# UNITED STATES PATENT AND TRADEMARK OFFICE

<b>Office Action Summary</b>	Application No. 10/786,981	Applicant(s) SULLIVAN, JAMES G.	
	Examiner Amy J. Sterling	Art Unit 3632

This is the first Office Action for application number 10/786,981 Emergency Vehicle Support Kit, filed on 2/25/04. Claims 1-21 are pending.

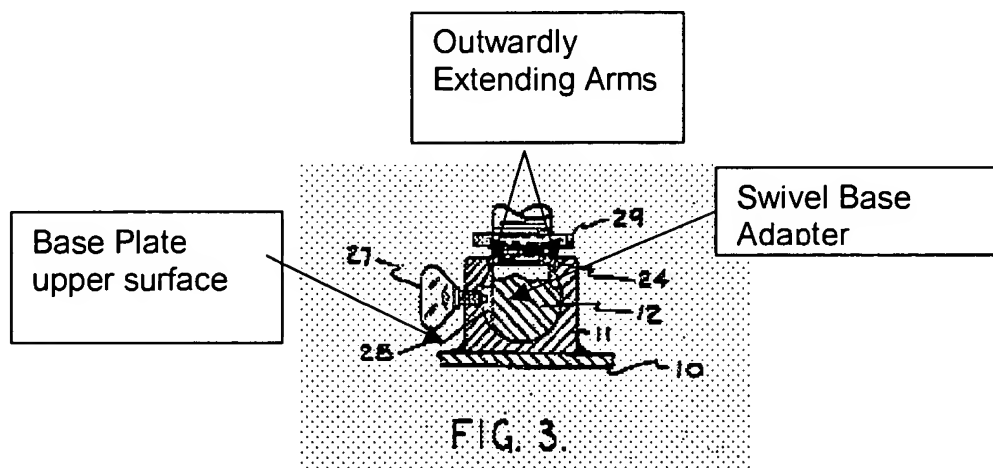
Claims 1 and 2 are rejected under 35 U.S.C. 102(b) as being anticipated by United States Patent No. 3171627 to Tapley et al.

The patent to Tapley et al. discloses a support having a cylinder (8), the cylinder having a continuous longitudinal wall, the cylinder having a longitudinal axis, the cylinder having a distal cylinder end and a proximal cylinder end, the cylinder having a cylinder diameter, the cylinder having a cylinder interior, a first piston (4), the piston having a continuous piston longitudinal wall, the first piston having a proximal first piston end and a distal first piston end, the first piston having a first piston diameter which is narrower than the cylinder diameter, the first piston being connected to the distal cylinder end, the first piston having a cylindrical interior, an uppermost distal second piston (6), the uppermost distal second piston having a continuous second longitudinal

wall, the second piston having a second proximal second piston end and a second distal second piston end, the second piston having a second piston cylinder interior, the cylinder, the first piston and the second piston being a telescoping device with at least two sets of linearly aligned apertures (each ends of the pistons is a set of apertures), the telescoping device further having attachments (upper 10) which grip a vehicle or building, a vehicle support base plate (10), the vehicle support base plate having an upper base plate surface (See Drawing Below), a swivel base plate adapter (12), the swivel base plate adapter rotating through an angle of approximately 130 degrees, Whereby, the swivel base plate adapter connects to the proximal cylinder end, and the swivel base plate adapter simultaneously connects to the vehicle support base plate, the cylinder attached to the first piston proximal end, the second piston attached to the first piston distal end, the second piston capable of sliding within the first piston interior, the first piston capable of sliding within the cylinder, the telescoping device forming a rigid support for a vehicle or building.

Tapley et al. discloses applicant's basic inventive concept, all the elements which are shown above and including teaching wherein the support base plate has two elevated base plate walls (11) with an outwardly extending arm (See Drawing Above) and wherein the base plate adapter (12) has a bottom most rounded surface contacting the vehicle support base plate.
